Bulletin 102

EI 1581 6<sup>th</sup> Edition Filter Water Separators

Apr 2017

*Diagram 1: screw fixing for 2" coalescers, illustrating how they differ from filter monitors*

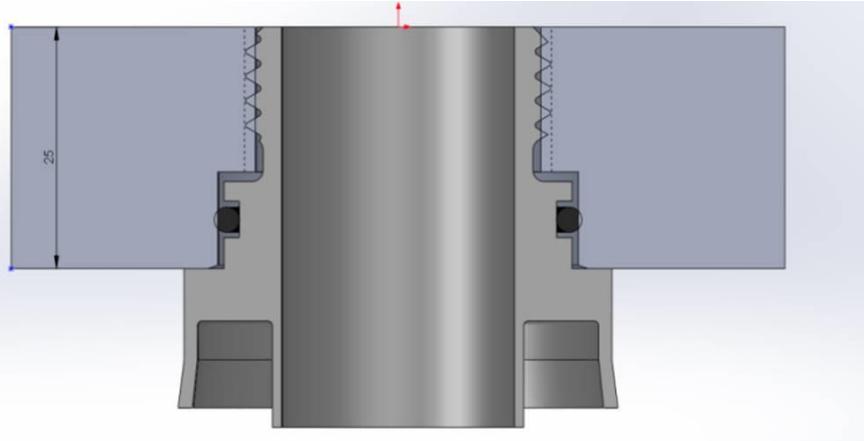
An engineering solution, as shown below, has been developed to avoid any possible confusion with other 2" diameter filter elements, i.e. filter monitors and microfilters (see Diagram 1). The end cap fitting for the new 2" diameter filter/coalescer elements is 5 mm wider than that used for filter monitor end caps and also of threaded configuration, so they cannot be fitted into a filter monitor vessel.

- element lengths for 50 mm (2 inch) nominal diameter coalescer and separator elements are standardized.
- 50 mm (2 inch) nominal diameter elements shall have a defined threaded base design, to avoid their misuse as filter monitors and vice-versa. (See diagram below)
